NUMBER: B402R1102-0

## SERVICE BULLETIN

Ride: WIPEOUT

Subject: Boom Limit Switch

Subject: Boom Pivot Pin Capscrew  
Retainer Installation

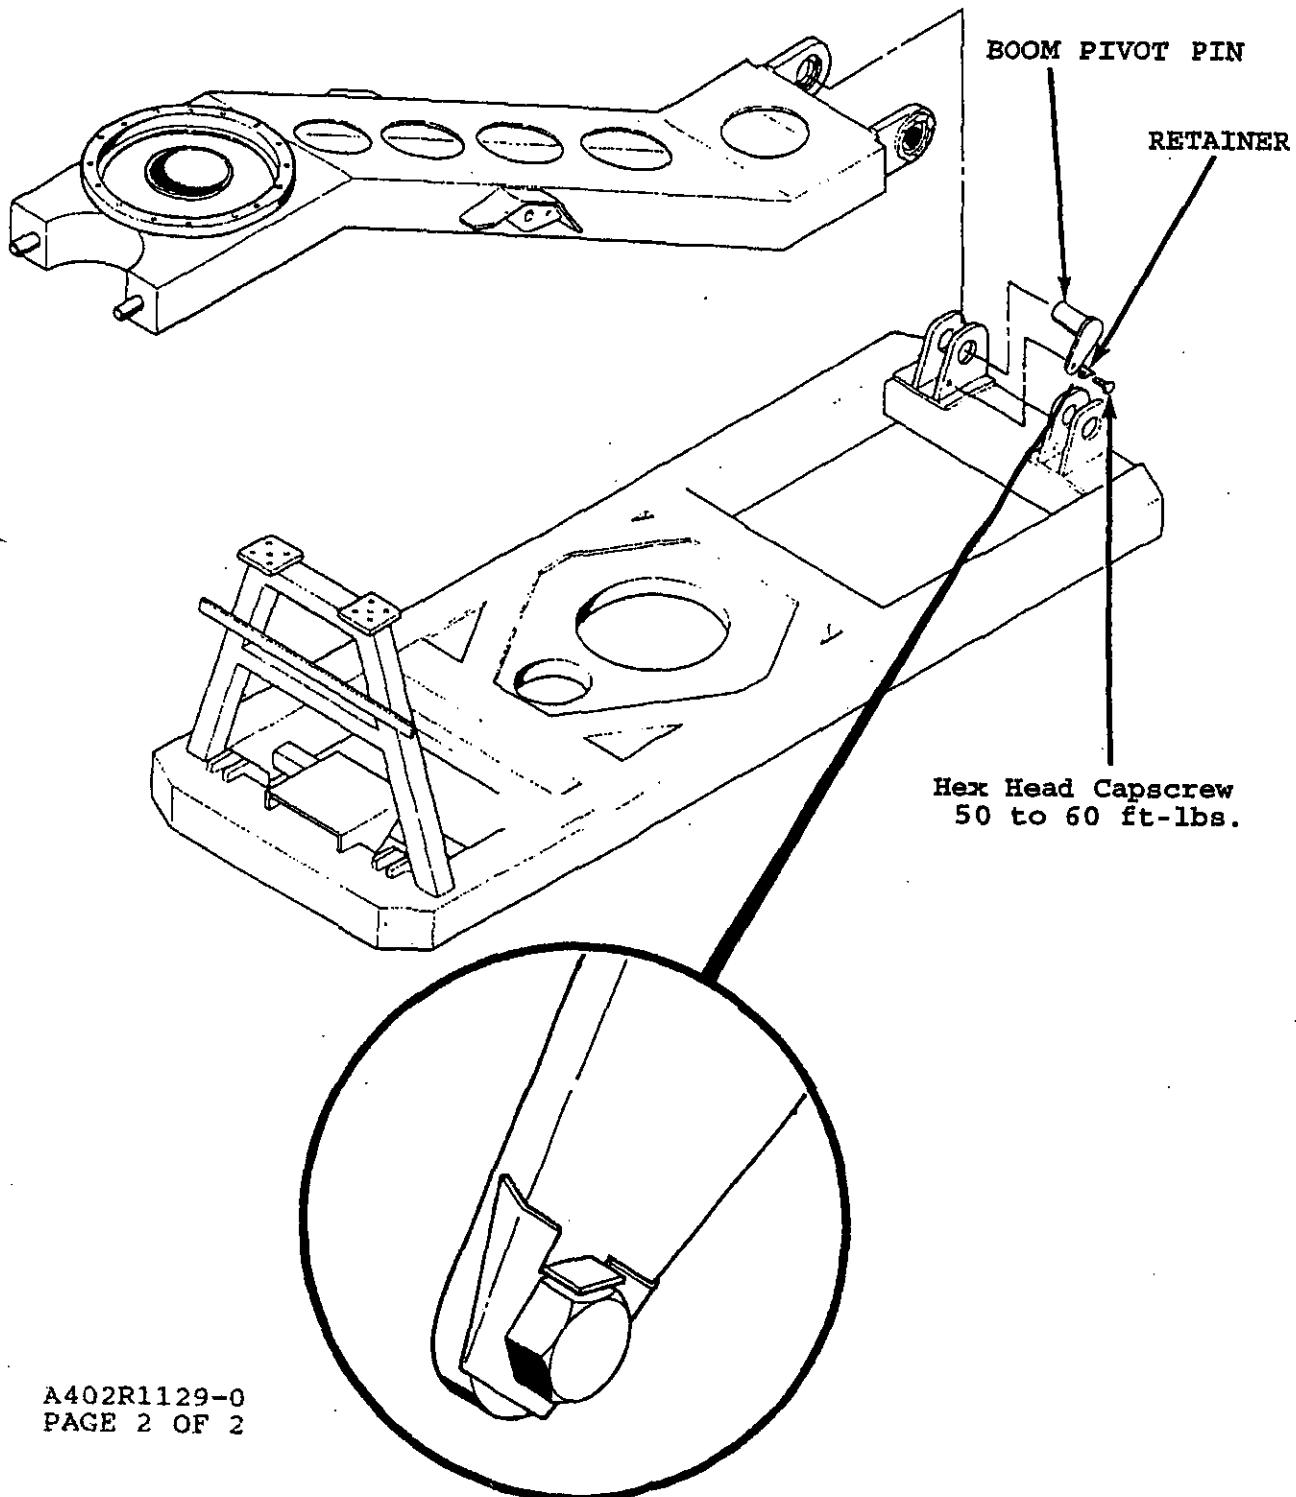
It has been determined by Chance Rides, Inc. that the hex head capscrews used to secure the boom pivot pin in place on the WIPEOUT amusement ride can become loose. If this happens, the pin may start to back out of the boom to turret joint. Damage to the ride and/or injury of passengers and personnel may result.

All owner/operators of the above noted rides are required to order and install the new locking hex head capscrews, part number 26432900 and capscrew retainers, part number 36018200. Two each are required per ride. Parts will be supplied at no charge if ordered within 90 days of the date on this bulletin.

1. Remove and discard the original capscrews and lock washers.
2. Install retainer and capscrew as illustrated, using 50 to 60 foot pounds with a torque wrench.
3. Bend the two tabs of the retainer down over the edges of the pin.
4. Bend the other tab of the retainer up against the flat side of the capscrew.

INSTALLATION INSTRUCTION - HEX HEAD CAPSCREWS

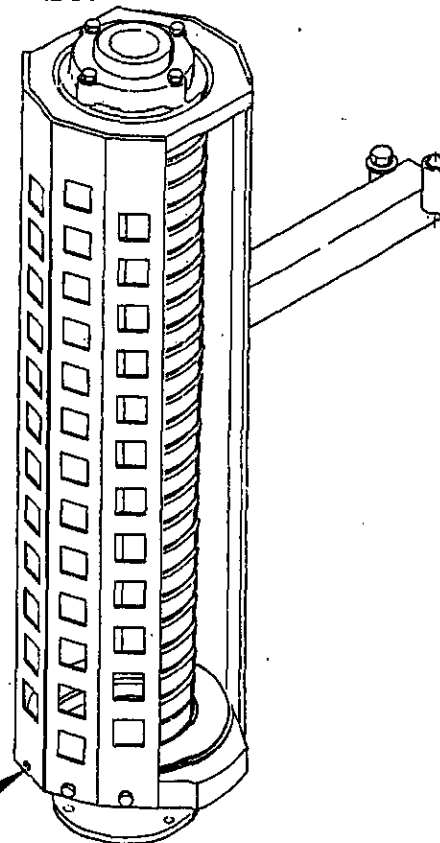
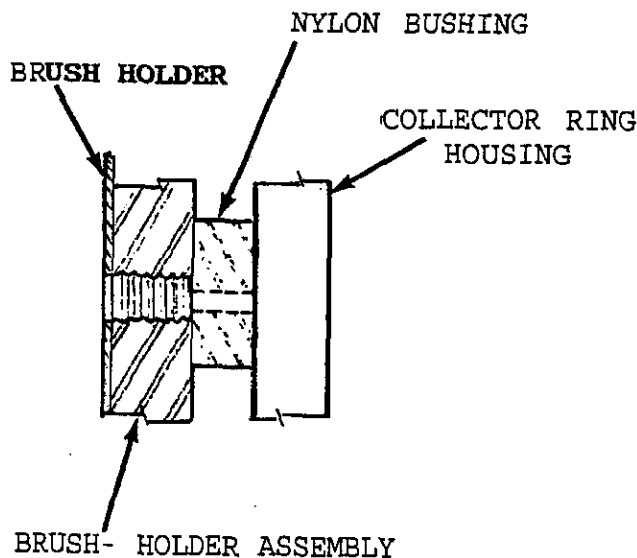
Chance Rides, Inc. has become aware that it is possible for the brush holder assembly and the collector ring housing on the WIPEOUT amusement ride to seize. If this happens, damage to the equipment can occur. To help prevent the brush holder assembly and the collector ring housing from seizing, Chance Rides, Inc. has developed a special capscrew which when properly installed permits lubrication of this assembly.

All owner/operators of WIPEOUT rides listed above are required to order and install, as outlined in this bulletin the special hex head capscrew, part number 38984500. Two of these special hex head capscrews are required per ride, one for each of the two collector ring housing assemblies. These parts are available at no charge if ordered within 90 days of the date on this bulletin.

NOTE: LOWER COLLECTOR RING ASSEMBLY SHOWN. UPPER COLLECTOR RING ASSEMBLY OPPOSITE

1. Turn power off to ride and disconnect the main power supply to the ride.
2. Remove the covers from the brush holder and collector ring assemblies. Retain the original hardware.
3. Remove and discard one of the 3/8 - 16 x 3/4 long hex head capscrews in each of the two brush holder assemblies.
4. Using a number 11 drill bit, drill a hole at the bottom of the hole from which the hex head cap screw was removed in step 3. Drill through the brush holder assembly and the nylon bushing.

NOTE: DO NOT DRILL INTO THE COLLECTOR RING HOUSING

5. Using a torque wrench, install the new hex head capscrews to 19-24 foot pounds.
6. Lubricate as specified in this bulletin.
7. Install the cover over the brush holder and collector ring housing assemblies using the original hardware.

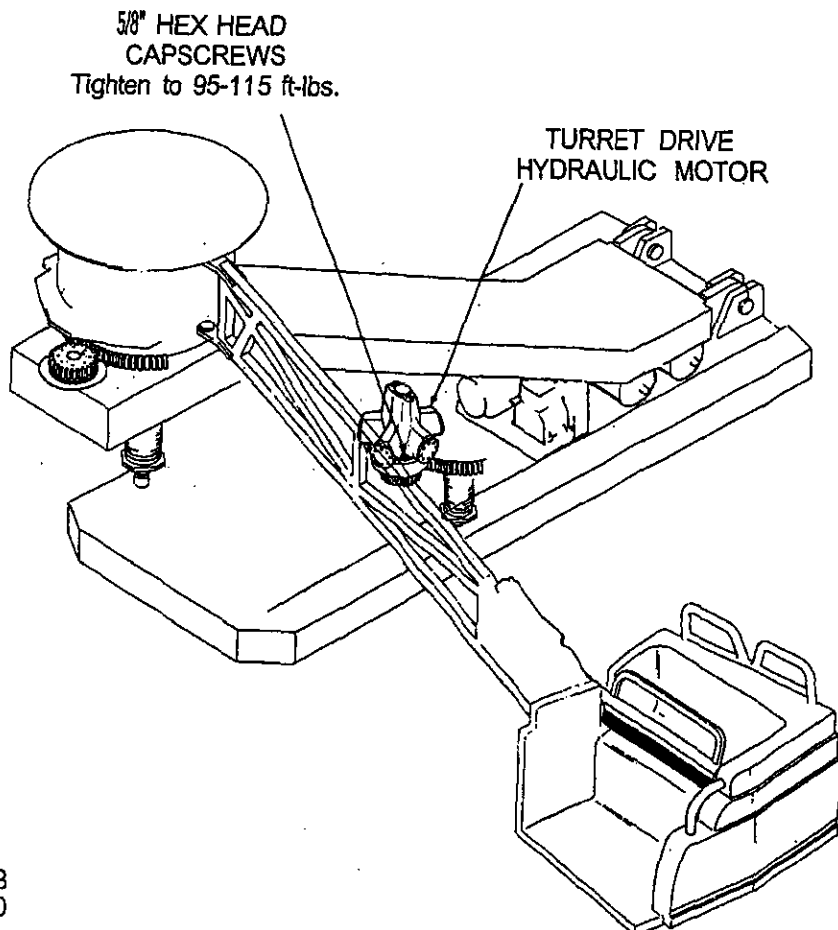
Chance Rides, Inc. has become aware that the socket head cap screws that secure the drive pinion to the bearing keeper for the turret drive of the WIPEOUT amusement ride can loosen. If this occurs, the pinion will become loose and could drop out of position, resulting in damage to mechanical parts.

1. Raise and block boom to give access to the turret drive motor and to stabilize boom while working under it.

2. Remove the five (5) 5/8-11 x 2 1/2 inch hex head cap screws that hold the hydraulic motor in place.
3. Raise the hydraulic motor to gain access to the bearing keeper.

BEARING KEEPER

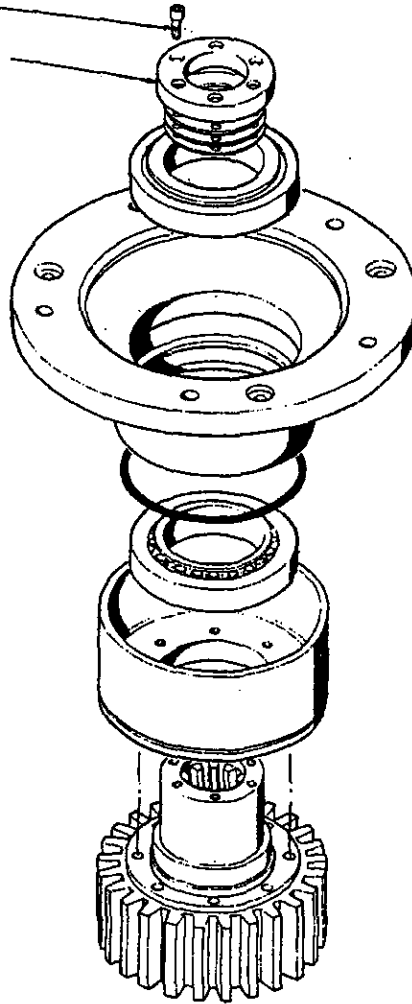
4. Check the torque (24 - 30 ft. lbs.) of the six (6) socket head cap screws holding the bearing keeper to the pinion.
5. If any of these socket head cap screws are loose, perform the following procedure:
  - a) remove the socket head cap screws
  - b) clean the threads
  - c) apply Blue Loctite 242 to the threads of the socket head cap screws and reinstall using 22 - 27 ft. lbs. of torque
6. Reinstall the hydraulic motor with the five (5) 5/8-11 x 2 inch hex head cap screws and 95 to 115 ft. lbs. of torque.

SOCKET HEAD  
CAPSCREWS  
Apply Loctite 242 Blue  
to threads. Tighten to  
22-27 ft-lbs.

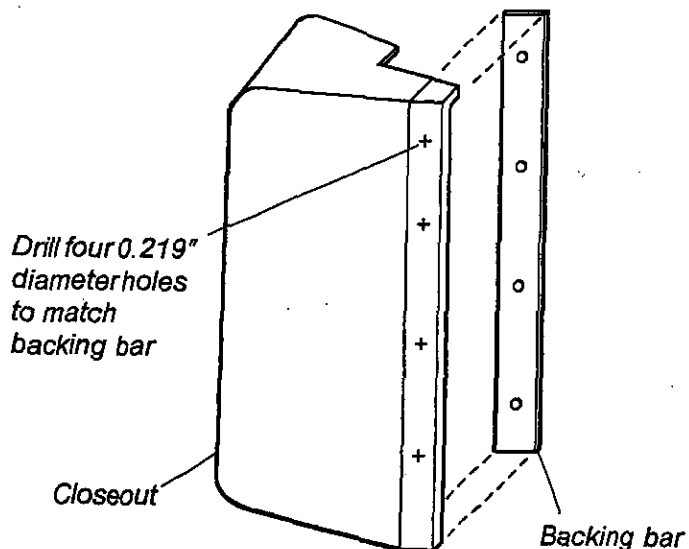
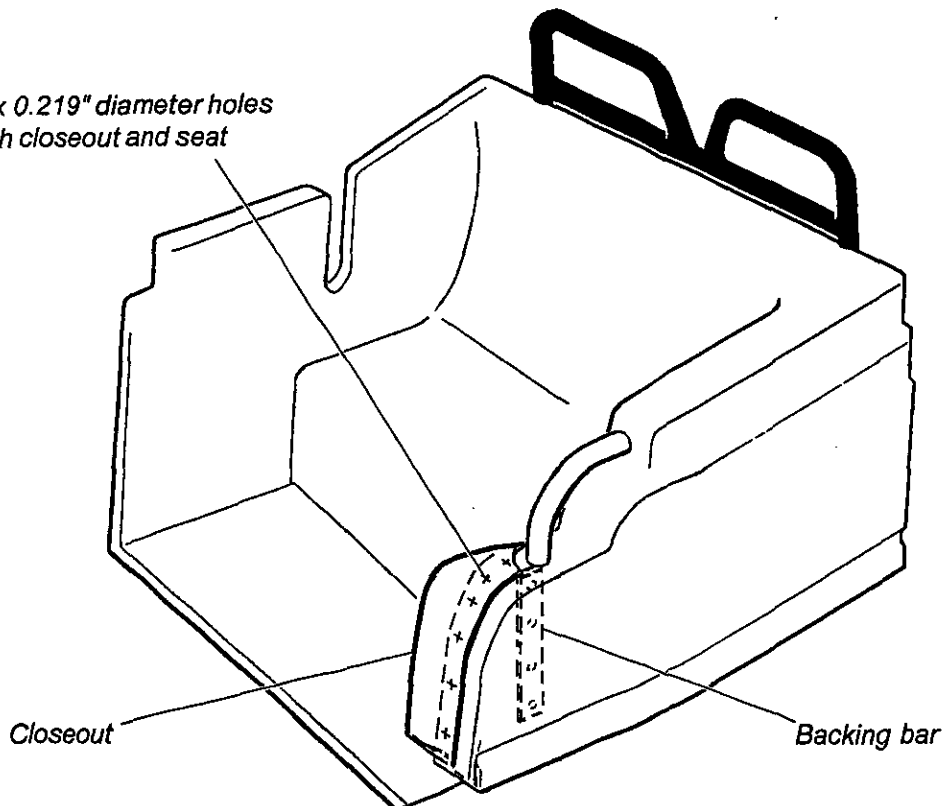
Chance Rides Manufacturing, Inc. has become aware that on the WIPEOUT amusement ride, it is possible for a passenger to extend his/her foot outside the seat. If this happens while the ride is in operation, serious personal injury to the passenger can result.

A seat closeout kit has been developed to help restrain the passengers' feet inside the seat.

1. Locate each seat closeout in position on the seat. If necessary, trim the seat closeouts as required to fit.

2. Using the backing bar as a template, drill four 0.219 inch diameter holes in the flange of the closeout to match the backing bar as shown.

3. Locate the closeout in position and use it as a template to locate and drill four 0.219 inch diameter holes in the seat. Also, drill six additional holes along the opposite side of the closeout as shown, going through the seat.
4. Insert the backing bar into the seat from the bottom side, aligning the holes in it with the holes in the seat and the closeout.
5. Use the rivets provided to attach the closeout to the seat at 10 places.
6. Repeat the procedure to install all 20 closeouts.

*Drill six 0.219" diameter holes  
through closeout and seat*

#### Determining the Correct Capscrew Length

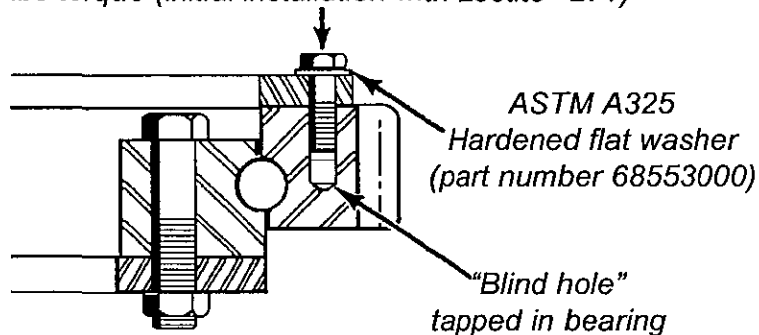
This bulletin is being released due to changes in the bearing by its manufacturer. As a result, the correct length of the capscrews varies depending upon the bearing which is installed in that specific ride.

The correct capscrew length is determined by the tapped holes in the bearing. If any of the capscrews are replaced, use the following illustrations to inspect the tapped holes in the bearing to determine the correct length of capscrew for that specific ride.

**1/2-13 x 1-1/2" long Grade 8 Hex Head Capscrew (part number 60849200)**  
80 ft-lbs torque (monthly check).  
90 ft-lbs torque (initial installation with Loctite® 271)
